Site Plan Review Committee (SPRC)
Staff Report for
1600 S Eads – Crystal Towers 3

Crystal Towers 3 (SPLA22-00018)
1600 S. Eads
(RPC#s 35-011-010, -011)

**SITE PLAN REVIEW COMMITTEE
MEETING AGENDA**

Sidewalk connection between building podiums.

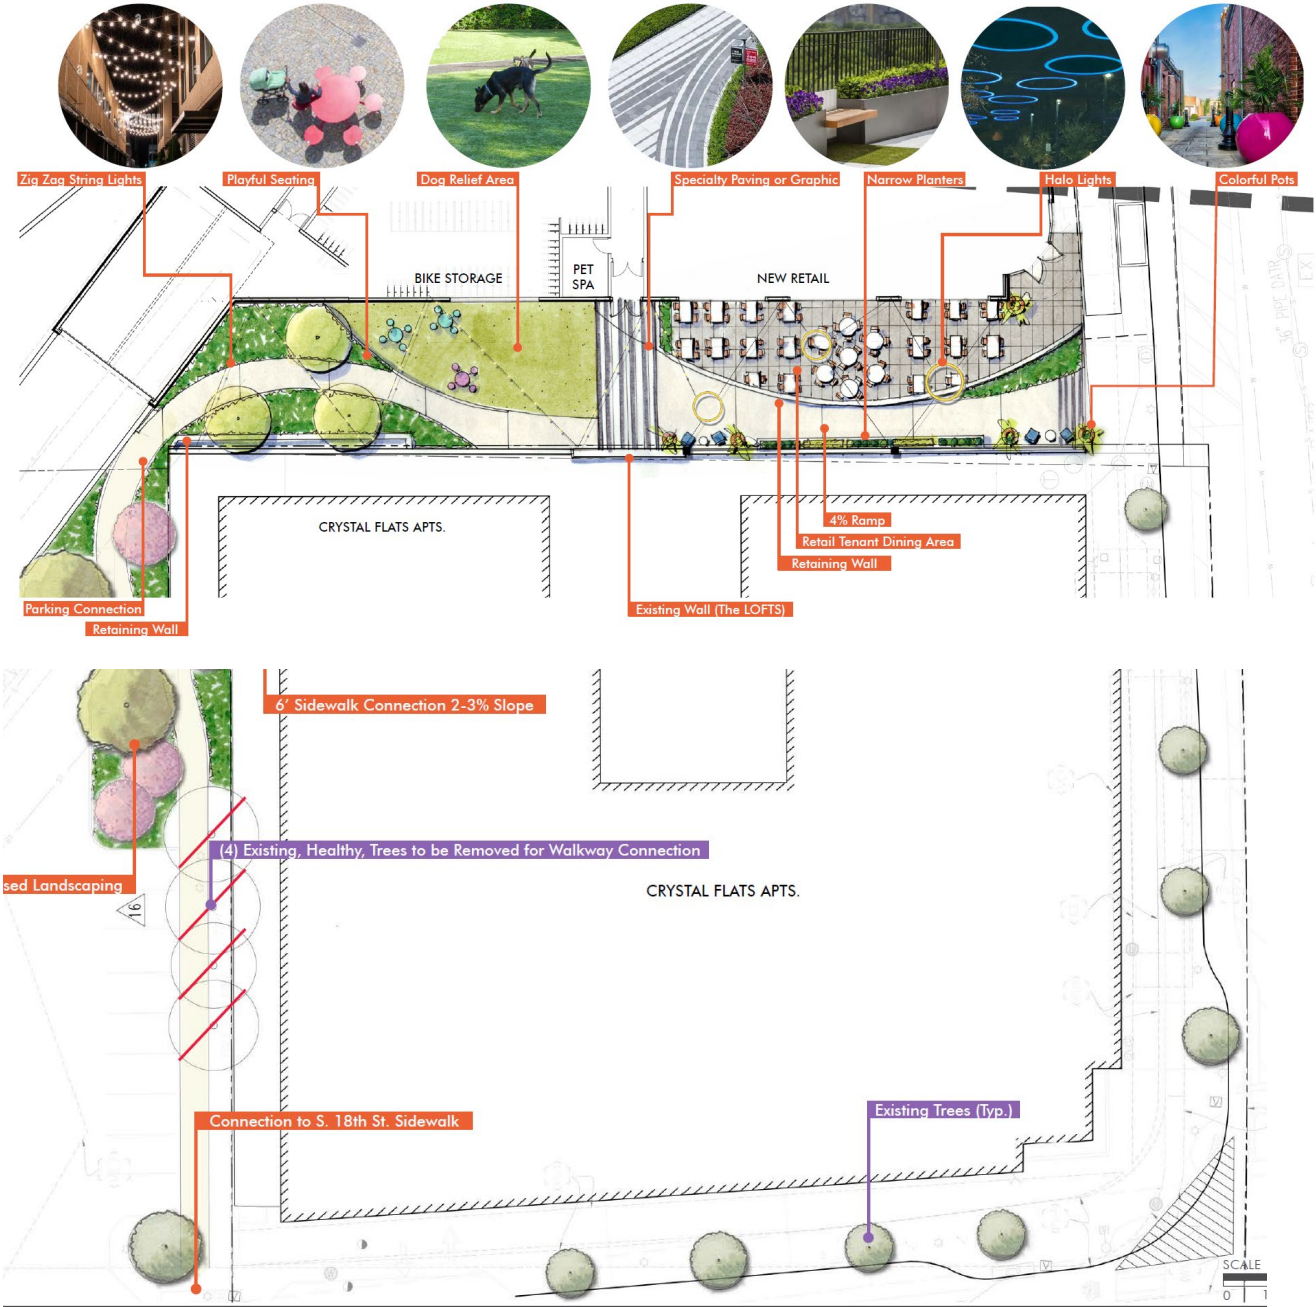
The sidewalk between the two podiums dead ends at the loading dock at the rear of the buildings. At the first SPRC meeting, SPRC members wanted to see that connect through the block to facilitate between pedestrian porosity through the site. The applicant has since studied that and developed a design to make that connection, however, it would result in the loss of four additional trees. This

redesign is under review by County Staff and will be a topic of discussion at the next SPRC meeting.

Figure 8: Building Height's Map – Crystal City Sector Plan

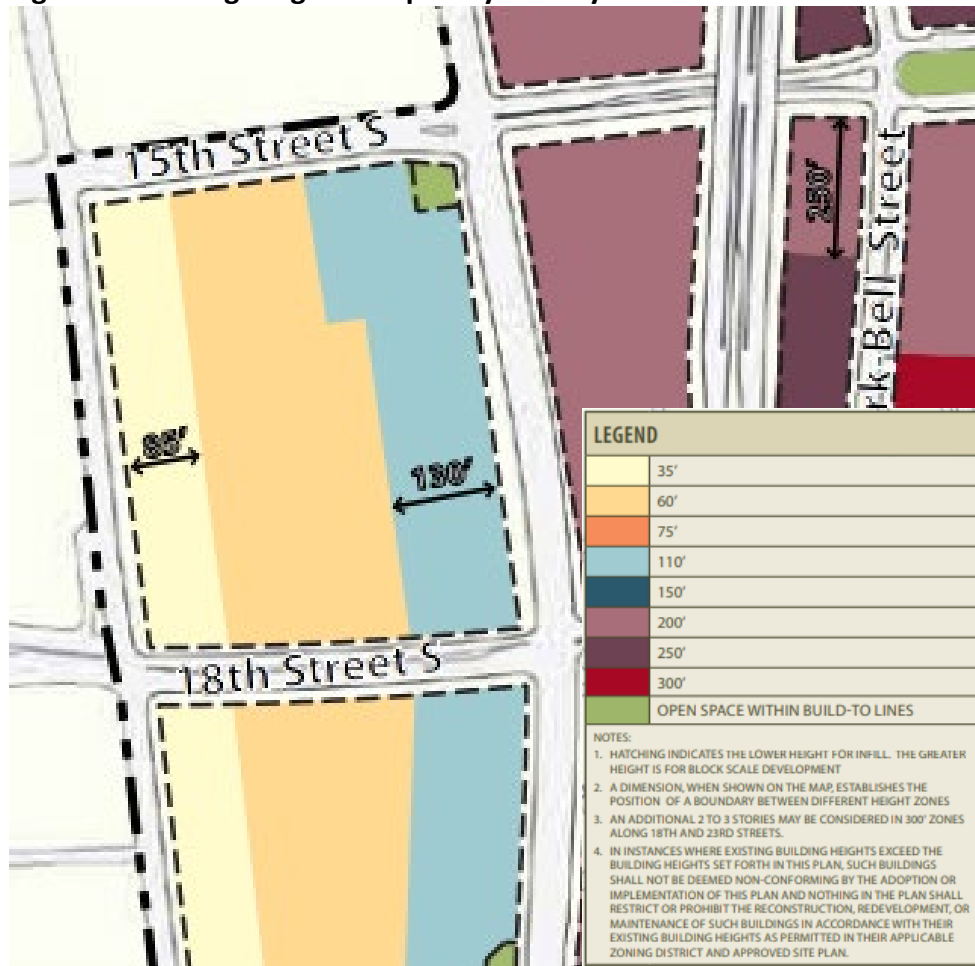
Building Height: The applicant is proposing a building height of approximately 132' for the residential building. The underlying zoning district of RA4.8 allows for a building height of 136' from average site elevation to the top of the building penthouse. The Crystal City Sector Plan provides guidance for a 110' building height on this site, tapering down to 60' and then eventually 35' (see figure 8). The Sector Plan's guidance is codified in the C-O-Crystal City zoning district, however, the applicant is not requesting a rezoning, so is not subject to the C-O-Crystal City building height. Staff continues to analyze this deviation from the Sector Plan to determine if it is acceptable at this location.

- **Maximum Allowable Height:** As noted above, the combined height of the podium and tower for development of the subject site should not exceed 110 feet and should taper down to 60' internal to the block and then 35' along S. Fern Street. As discussed above, the proposed residential building is not consistent this guidance.

Figure 9: Crystal City Sector Plan Design Buildable Envelope and Massing Strategies

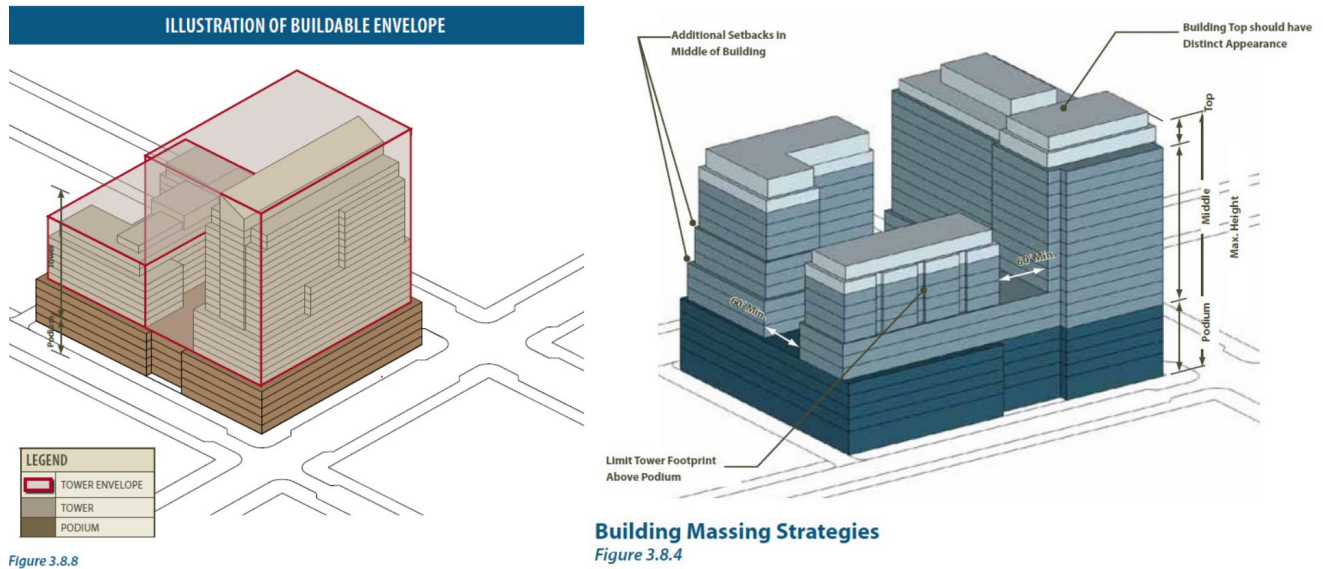
Building Form, and Architecture: Section 3.11 of the Crystal City Sector Plan provides Design Guidelines for use as reference in the redevelopment of Crystal City. These guidelines contemplate redevelopment buildings for full blocks, and not necessarily the in-fill type buildings that the applicant is proposing. These guidelines recommend that all new and substantially renovated buildings incorporate a design scheme that provides a distinct podium, middle and top. As defined by the Crystal City Sector Plan, the podium consists of the lower five (5) to six (6) stories (or less) of the building, while the remaining stories consist of the middle and top elements that comprise the building’s tower. The middle consists of those stories above the podium, but excluding the top elements that are defined as the upper two (2) to four (4) stories. The guidelines “are intended to be flexible” and many are “aimed at allowing adequate sunlight to reach public streets and open spaces, as well as achieving a level of architectural interest, articulation, and sculpting currently lacking in Crystal City.” These guidelines achieve multiple goals, including: regulating achievable densities; realizing pedestrian-oriented design of new development; creating a visually interesting skyline; and ensuring adequate sunlight for public spaces. The proposed residential building has a podium that consist of the first four stories and the proposed retail building is a single-story building that does not have a podium, middle, and top because of the height proposed.

o Top of the Podium: The Sector Plan recommends that the top of the podiums have a horizontal architectural unity through the use of cornices or other banding projections placed at the top of the upper most floor of the podium. The proposed residential building does not have an architectural treatment that distinguishes the top of the podium.

- o Building Setback Profiles: The Sector Plan recommends two (2) approaches for achieving sculpted buildings with distinct podiums, towers, and tops – a Multiple Setback Approach, and a Single Setback Approach. While the podium should continuously engage the Build-to Line and meet the back of the sidewalk, the tower massing above should taper or step back from the podium along streets and open spaces to achieve aesthetically interesting and attractive buildings, and to allow for light and air between buildings. For building tops, it is generally recommended that the upper two (2) to four (4) floors of all buildings should be no closer than 20 feet from the Build-to Line, unless the proposed design of the building top involves a dramatically creative architectural treatment that is integral to the overall composition of the building. The step-back approach for the proposed residential building and staff will continue to evaluate whether these deviations detract from the overall Sector Plan objectives.

Figure 11: Public Open Space Improvements

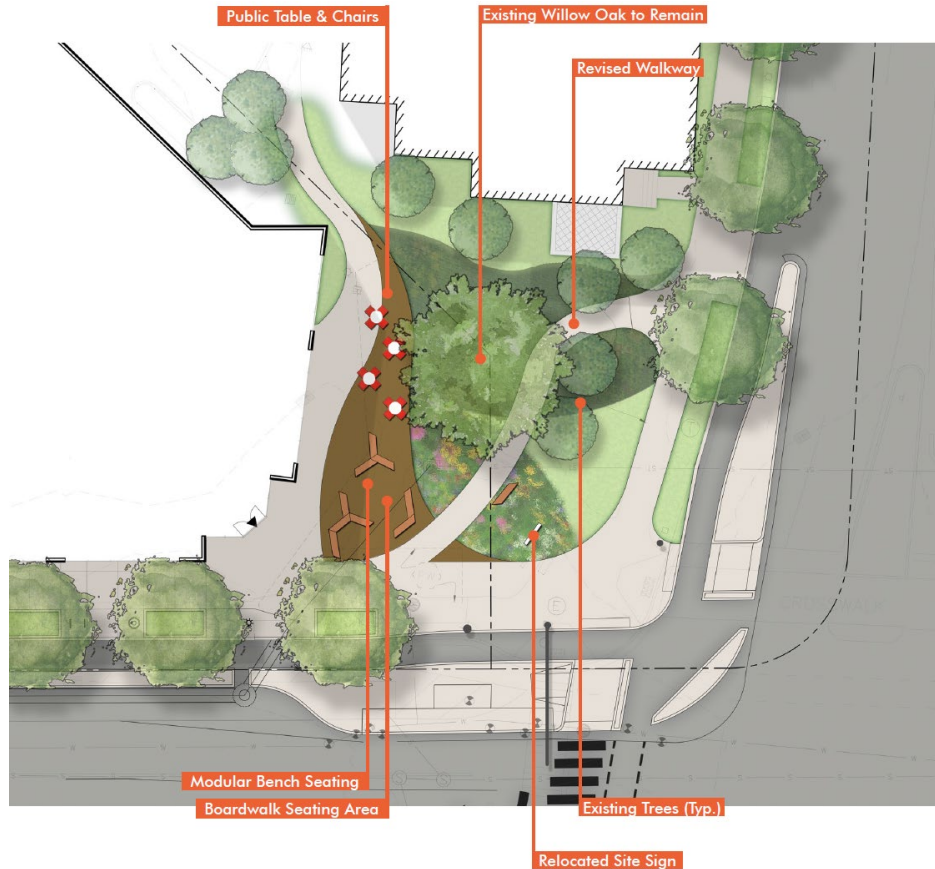
Public Open Space: The Sector Plan identifies an existing passive open space on the corner of 15th Street and S. Eads Street, identified as Open Space #18. Today, the open space area is less than the 6,000 sqft that is called for in the Sector Plan. The applicant is proposing to increase the size of the open space from the existing 4,345 sqft to 5,045 sqft by providing an additional public access easement.

The applicant is proposing to make some improvements to the open space area, shown in the image below. The proposed improvements are subject to changes and refinement through the landscape plan process, but are proposed to include a boardwalk area with public tables and chairs, bench seating, new pathways, and conservation of some mature existing trees.
